***GEOTECHNICAL REVIEW REPORT  
TENTATIVE TRACT MAP NO. 82349  
CHADWICK RANCH, CITY OF BRADBURY  
LOS ANGELES COUNTY, CALIFORNIA***

***October 9, 2019  
J.N. 17-219***

**Subject: Geotechnical Review Report, Tentative Tract Map No. 82349, Chadwick Ranch, City of Bradbury, Los Angeles County, California**

PETRA GEOSCIENCES, INC. 28358 Constellation Road, Unit 680 Valencia, California 91355 PHONE: (661) 255-6790 COSTA MESA TEMECULA VALENCIA PALM DESERT CORONA	
GEOTECHNICAL MAP Chadwick Ranch City of Bradbury, California	
DATE: OCT. 2019 J.N. 17-219	PLATE 1

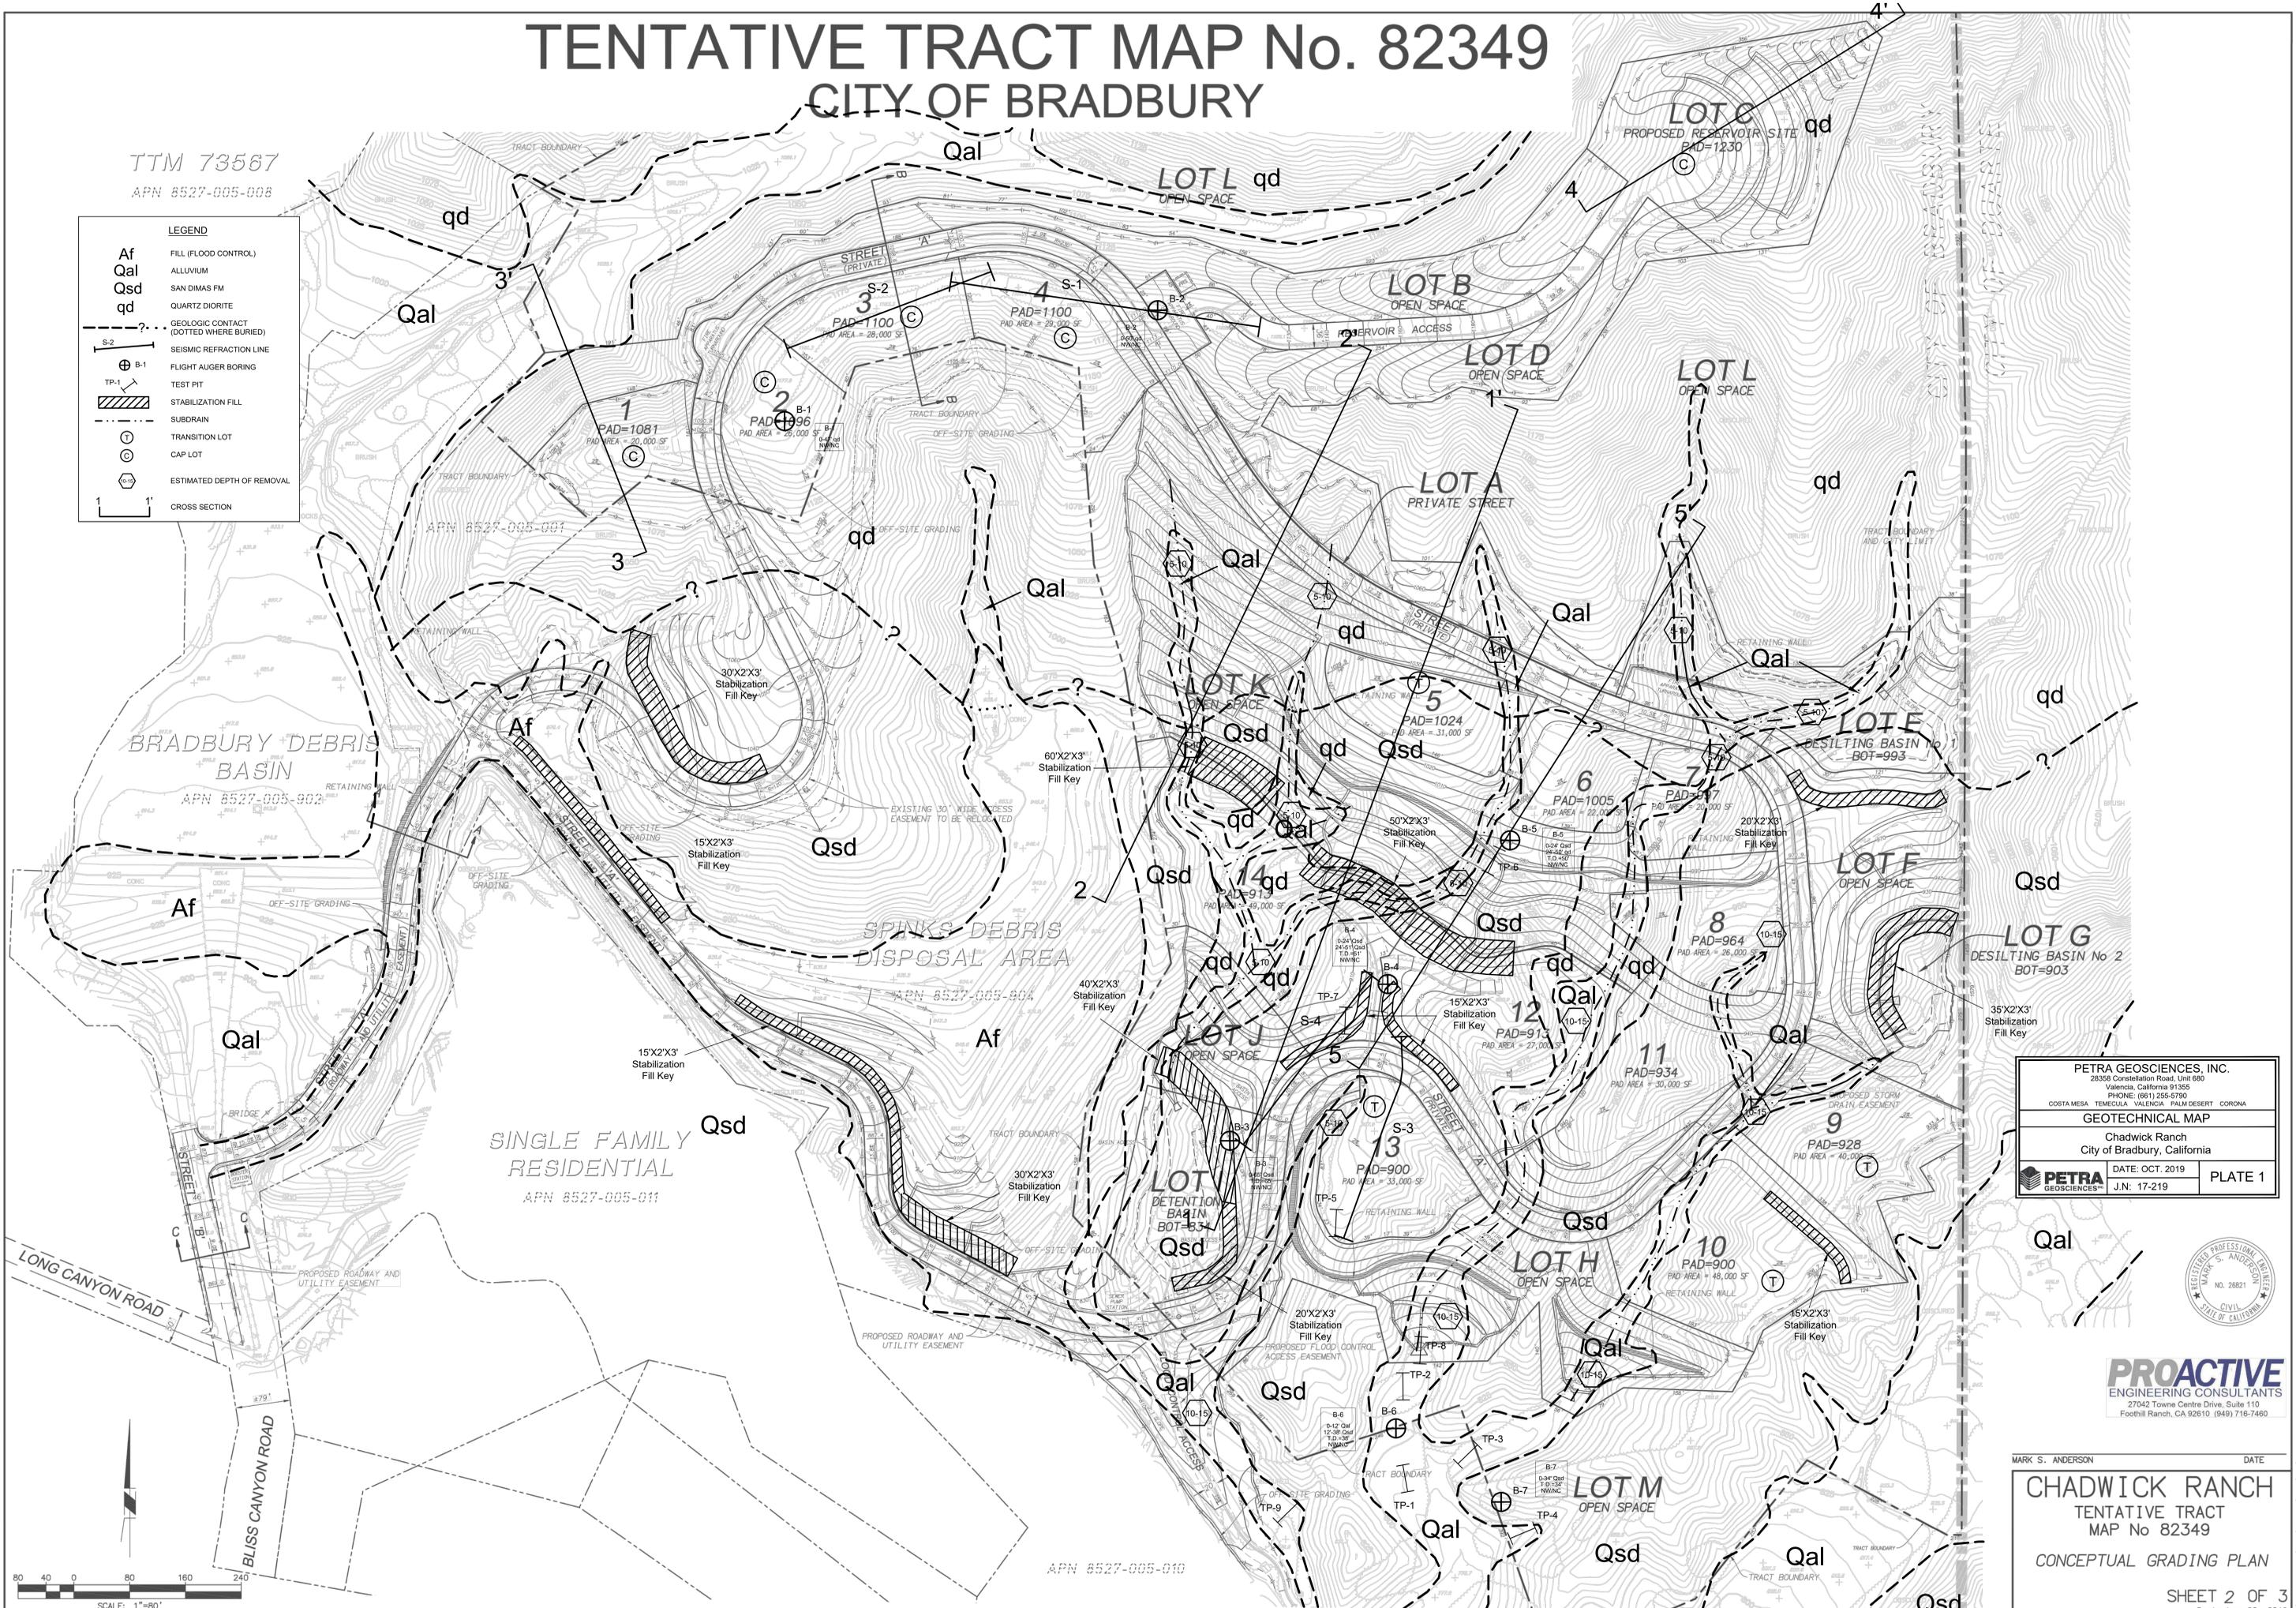
Based on our subsurface investigation and analysis, development of the site as shown on the enclosed 80-Scale Grading Plan is considered feasible from a geotechnical point of view.

All existing artificial fill, natural soils, alluvium and weathered bedrock and alluvial fan deposits shall be removed from areas planned to receive fill or where exposed at final grade. The resulting voids should be replaced to design grade with engineered fill. The exact extent of removals can best be determined in the field during grading when observation and evaluation can be performed by the soils engineer and/or engineering geologist. Removals should expose competent, unweathered bedrock/alluvial fan deposits and be observed and mapped by the engineering geologist prior to fill placement. Approximate depths of unsuitable material removal/overexcavation are indicated on the accompanying Geotechnical Map (Plate 1) and are depicted on the geologic/geotechnical cross-sections.
